Land south of the M20, Church Lane, Aldington, Kent (known as East Stour Solar Farm)

Proof of Evidence by DP Withycombe MSc CMLI on behalf of Ashford Borough Council

Appendix 1: Aldington: East Stour Solar Farm Environmental Statement Volume 2A -
Written Statement and Appendices (April 2022) Initial Comments on ES Chapter 11:
Landscape and Visual Impact (Land Management Services Ltd 5th December 2022)

Appendix 2: Aldington: East Stour Solar Farm SEI Chapter 11 Landscape and Visual
Impact - Written Statement and Appendices (January 2024) (Land Management Services
Ltd 23rd February 2024)

SEI Figure: 11.9 Revision B
Mitigation Plan

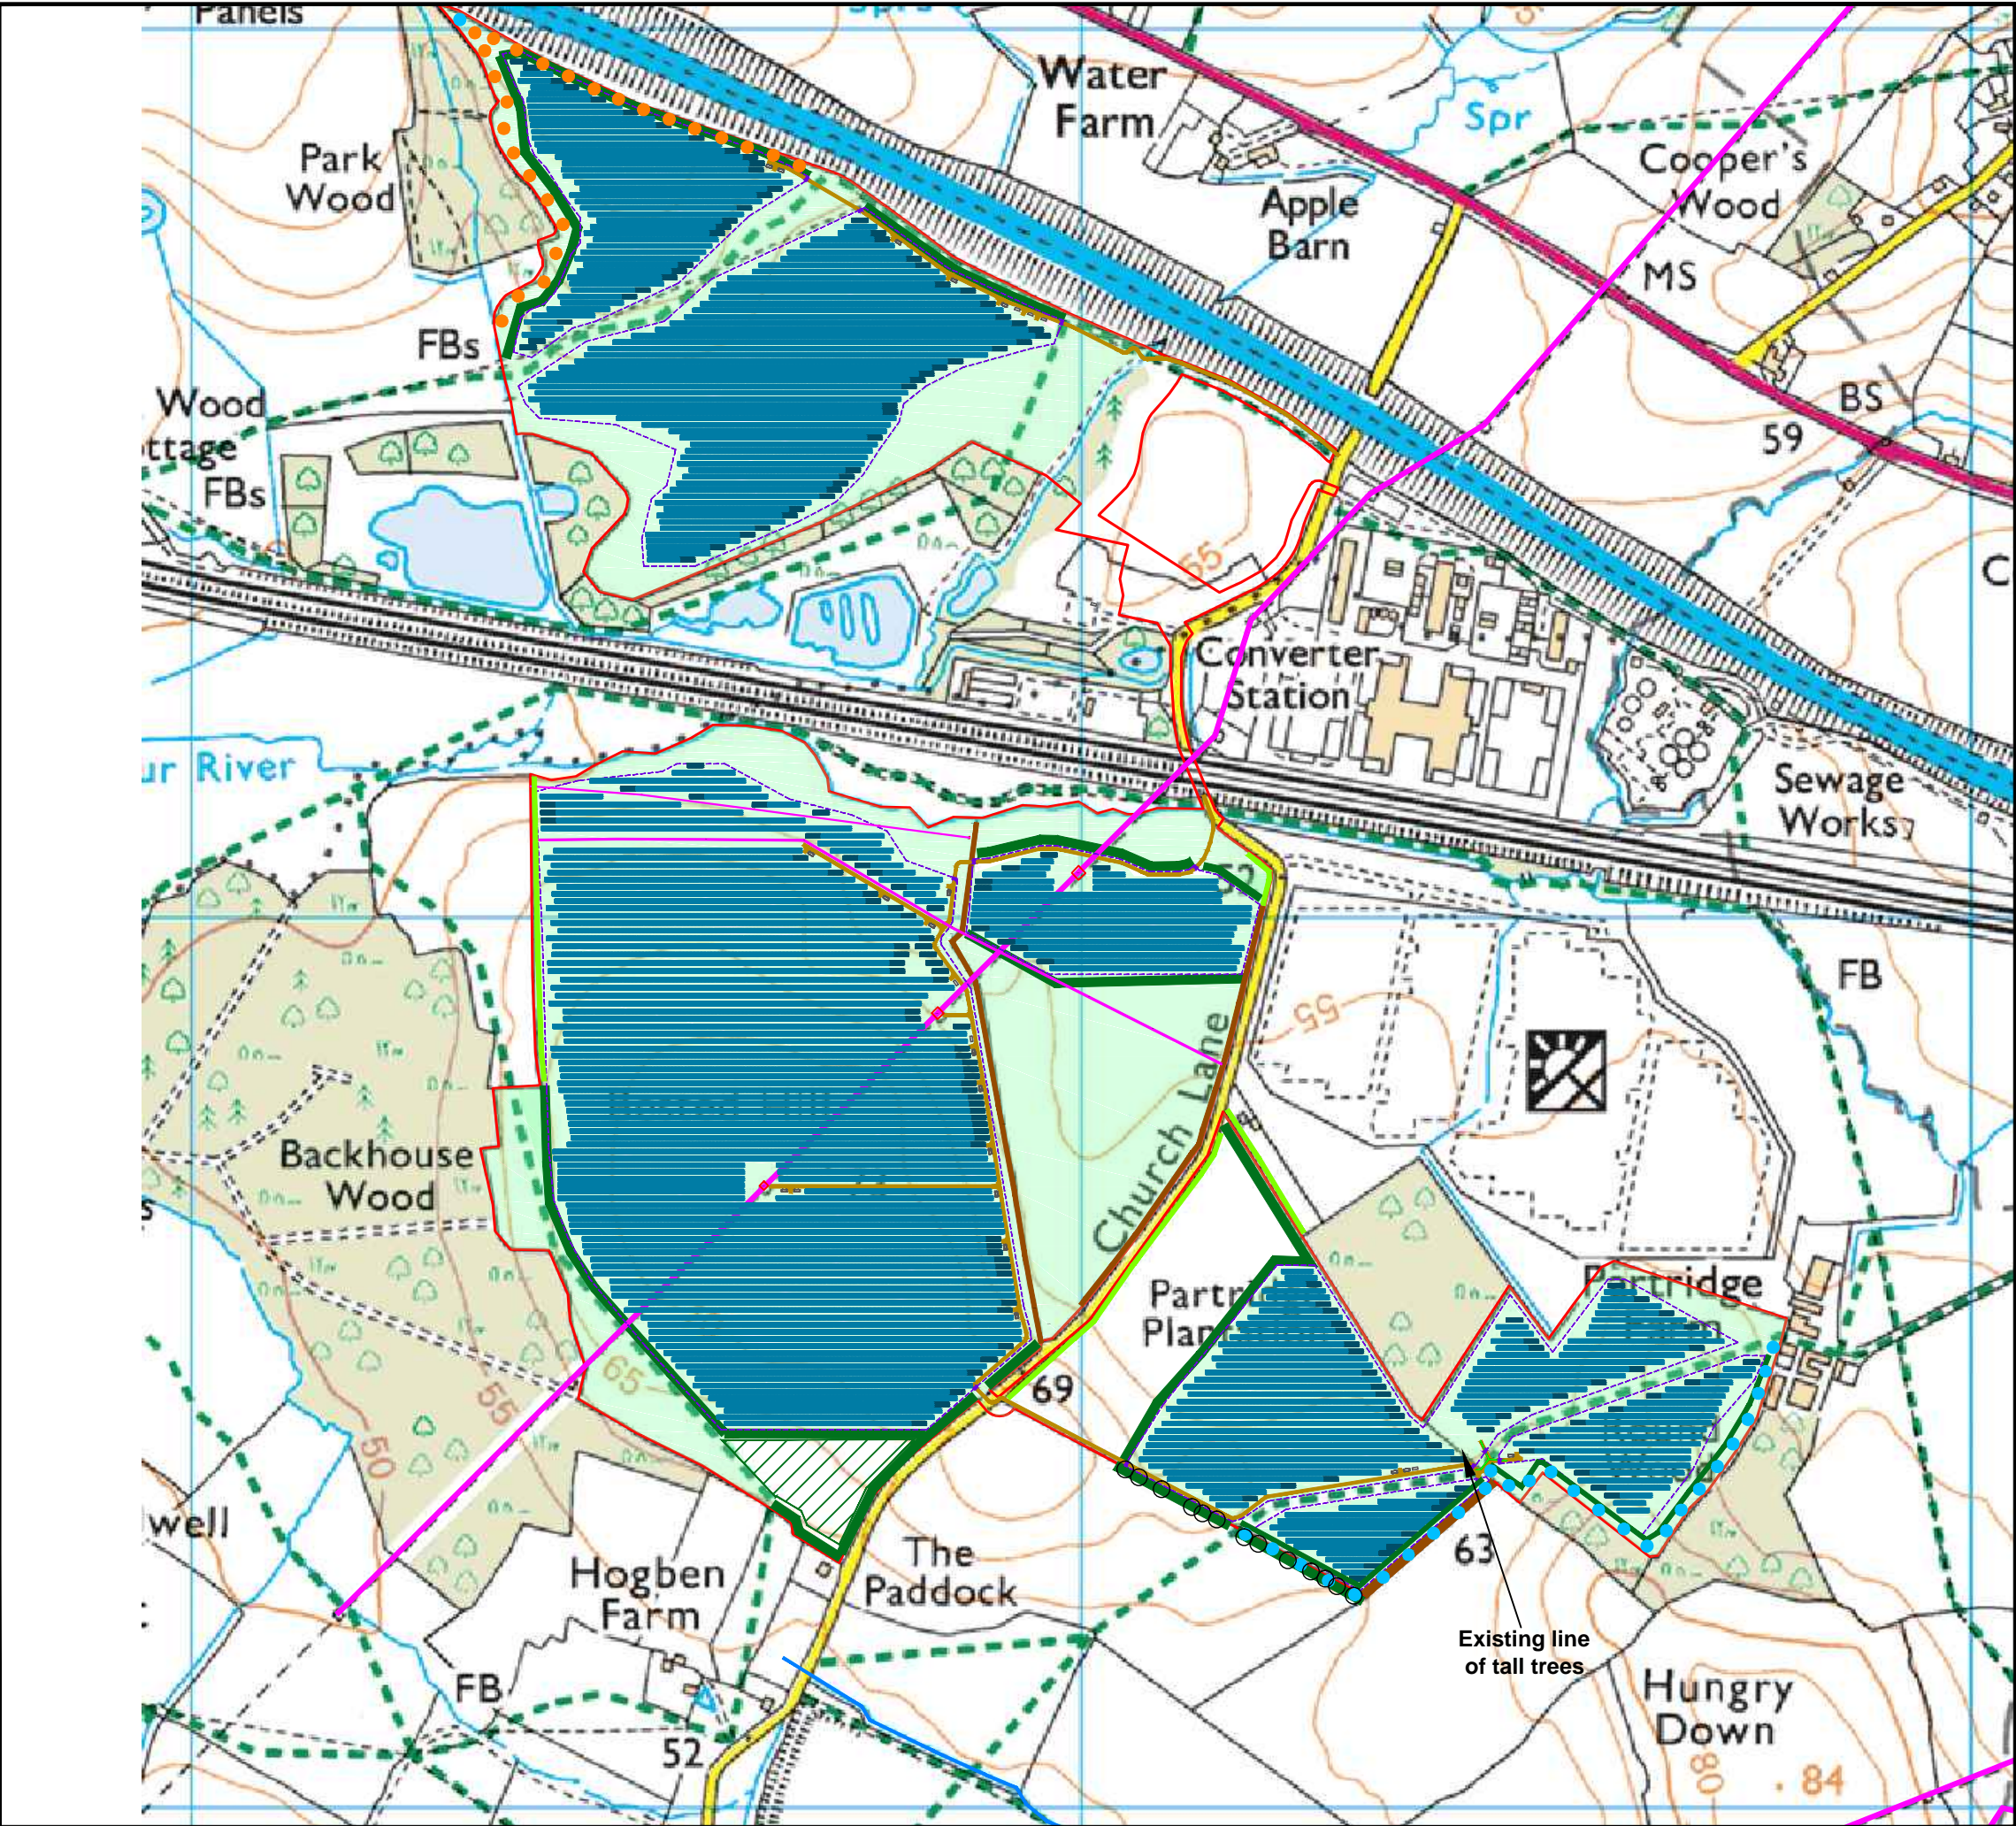
Section 2 of SEI Chapter 11 discusses the Mitigation Rationale. The SEI includes a revised and annotated Figure 11.9 Rev A Mitigation Plan, which includes additional native hedgerow planting or existing hedgerow enhancement at selected locations, and a series of cross sections representing the landscape proposals associated with Public Rights of Way within the application site. The locations are shown on Figure 11.14 Cross Section Locations. These additional plans are helpful in understanding the anticipated impacts and effects of the proposals on the PRoWs and the experience for PRoW users.

The SEI includes enhanced mitigation proposals at Figure 11.9. There is, however, no indication in the SEI that this would reduce the anticipated impacts and effects described in the April 2022 EIA.

EDF Application Plan: Green line inserted showing panel area to be removed on south facing slope of Bested Hill

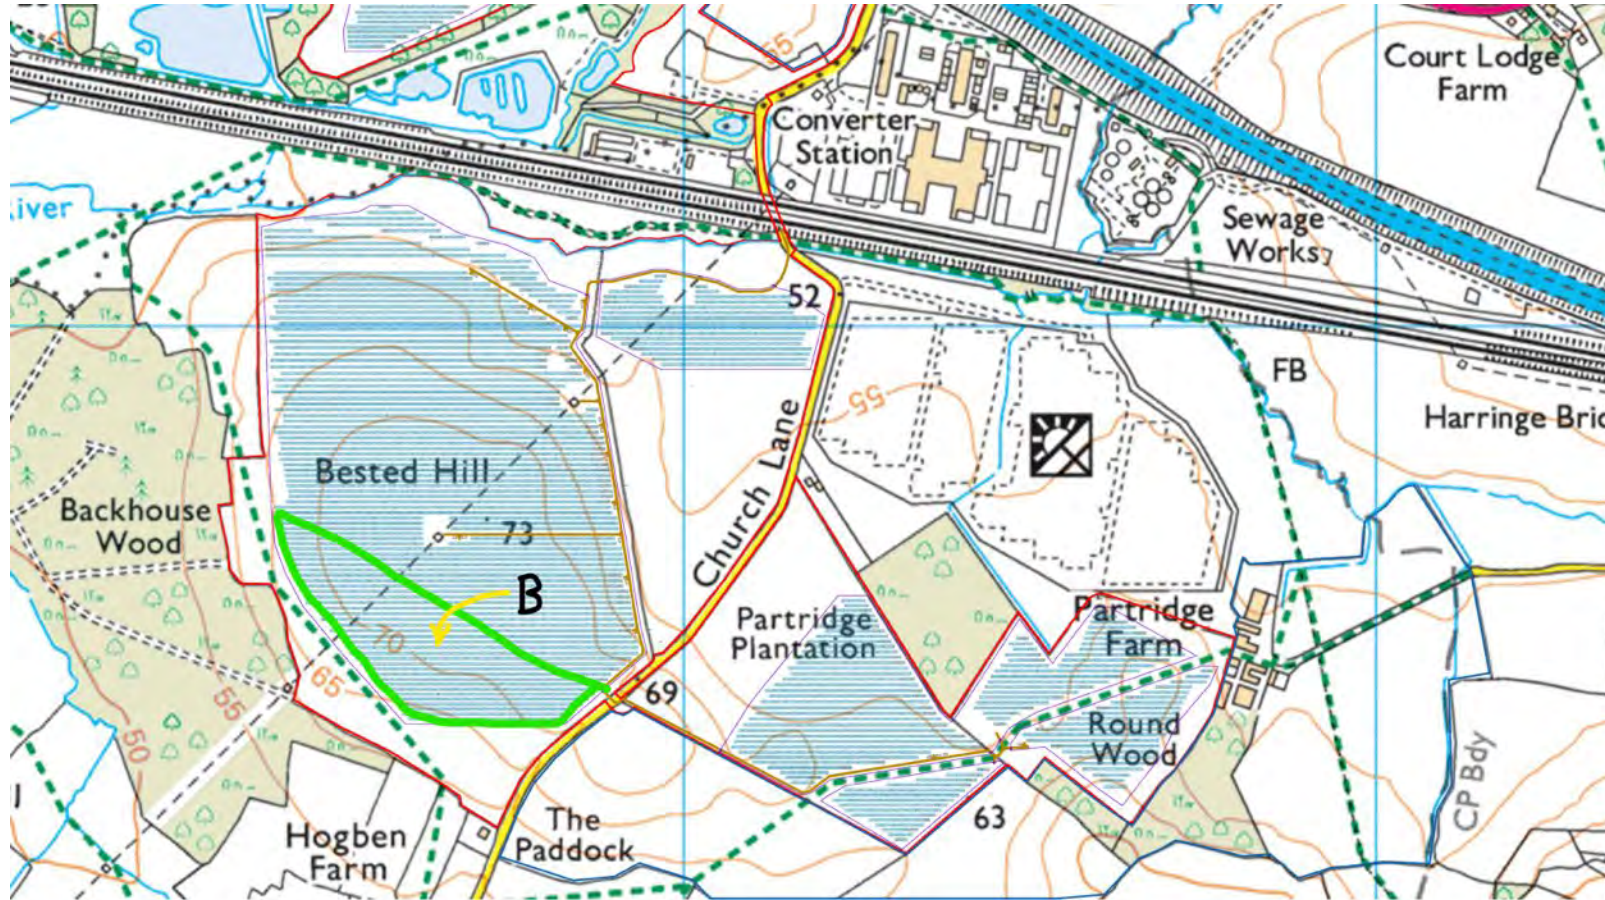
Extent of area to be removed. Approximately 15 – 20 acres of solar panel footprint
